DESCRIPTIVE REPORT

Type of Survey Hydrographic Field No PE-10-4-81 Registery No H-9937.
LOCALITY
State U.S. Virgin Islands General Locality St. Croix
SublocalityFredericksted to Hams Bluff
1981 CHIEF OF PARTY
CDR D.E. Nortrup
LIBRARY & ARCHIVES
DATE October 14, 1986

ATLANTIC MARINE CENTER EVALUATION REPORT

REGISTRY NO.: H-9937 FIELD NO.: PE-10-4-81

15 017 K M NMA DE WTEQ RRRR OSL 261841Z AND 2619507 KKK V 15 02 DIVE REPORT: OPR-I149-PE-81/DV 2 DIVE DATE: 19 April 1981

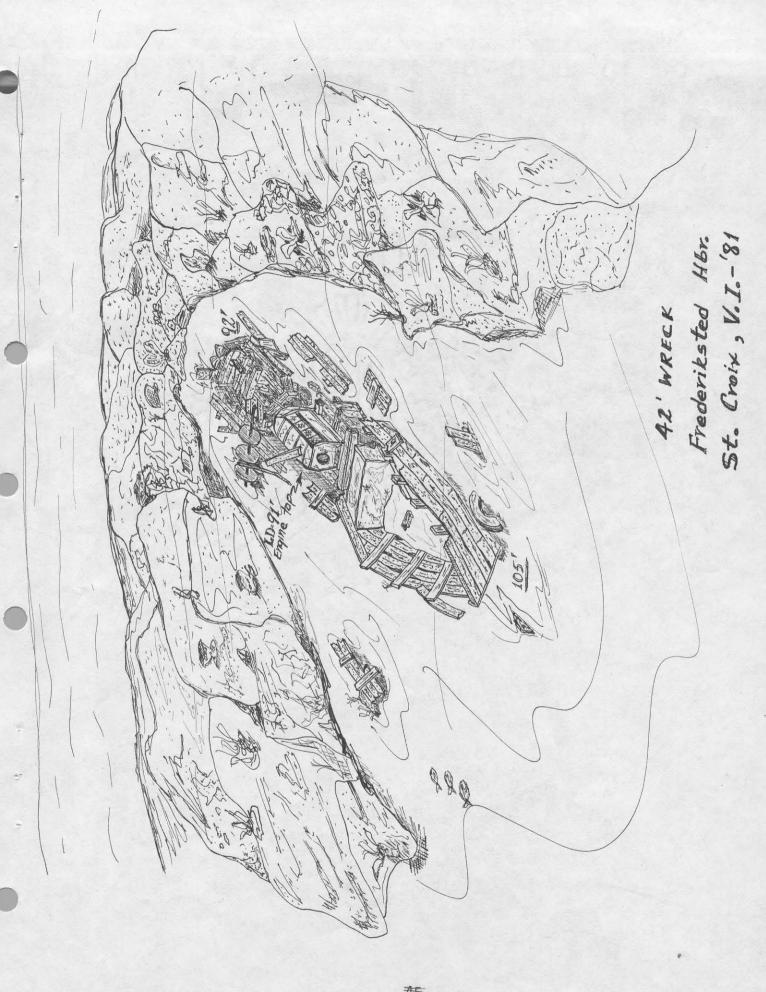
No charting action is recommended. Because of the depth of water, characteristics of this wreck, that is its relatively small size and position on the slope and the coral surrounding it on three sides (the fourth is the bottom drop-off), it is physically impossible and totally illogical to consider this as a danger to navigation. However, if a symbol must be assigned, it should be that designating a non-dangerous wreck.

Do not concur. Chart sunken wreek as 15 WK
